1 GREENLINE REVISION 8/25/08
TEDD APPROVAL Jennifer Biddle
2 GREENLINE REVISION 9/18/08
TEDD APPROVAL Jennifer Biddle
3 Red line
TEDD W. Hood 3/4/09

MD 198 (TALBOT AVE) AND 8TH ST

TRAFFIC SIGNAL PLAN

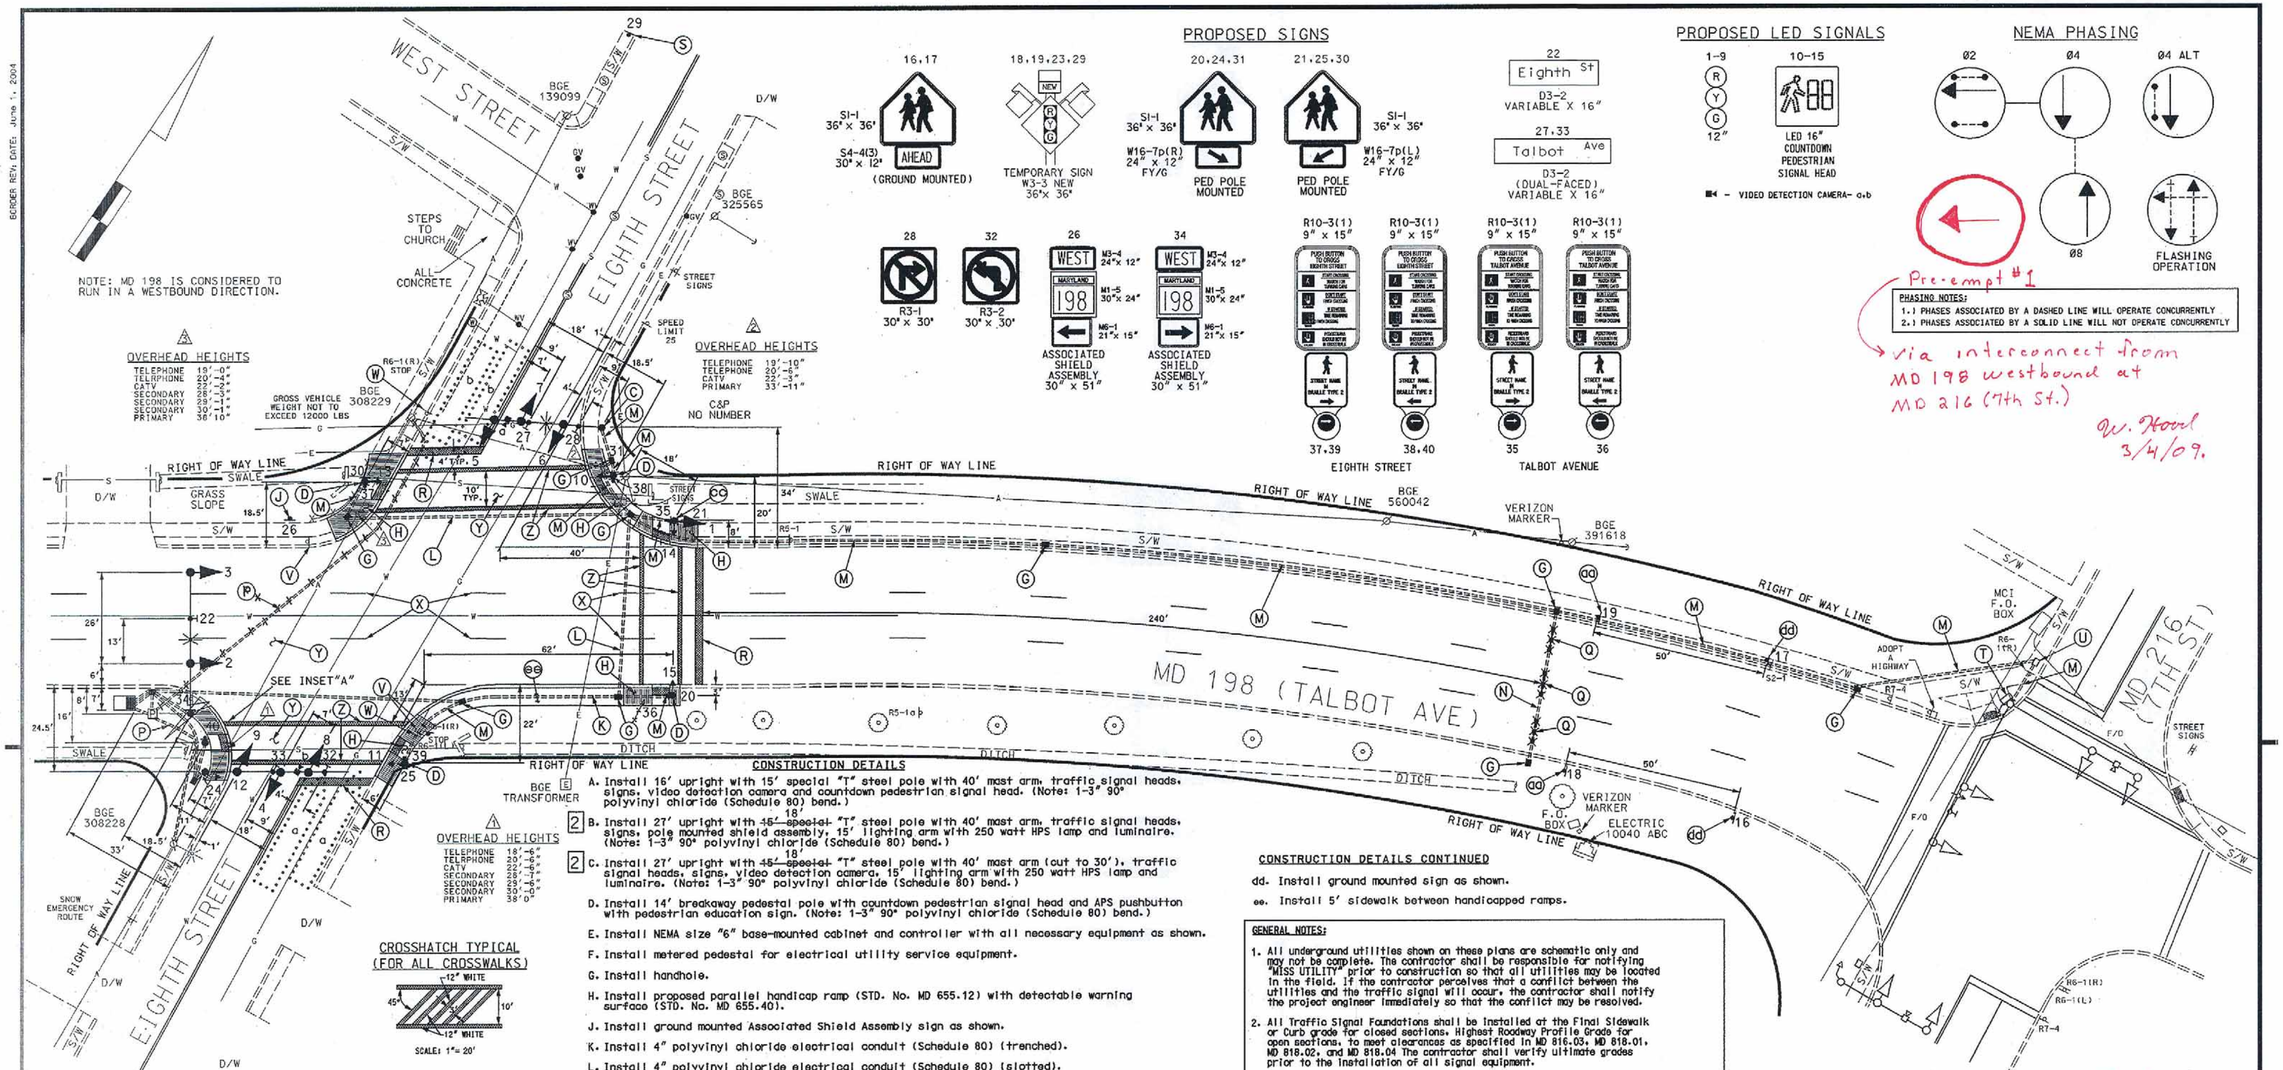
W. Hood 3/4/09.

2 B. Install 27' upright with ~~15' special~~ 18' "T" steel pole with 40' mast arm, traffic signal heads, signs, pole mounted shield assembly, 15' lighting arm with 250 watt HPS lamp and luminaire. (Note: 1-3" 90° polyvinyl chloride (Schedule 80) bend.)

2 C. Install 27' upright with ~~15' special~~ 18' "T" steel pole with 40' mast arm (cut to 30'), traffic signal heads, signs, video detection camera, 15' lighting arm with 250 watt HPS lamp and luminaire. (Note: 1-3" 90° polyvinyl chloride (Schedule 80) bend.)
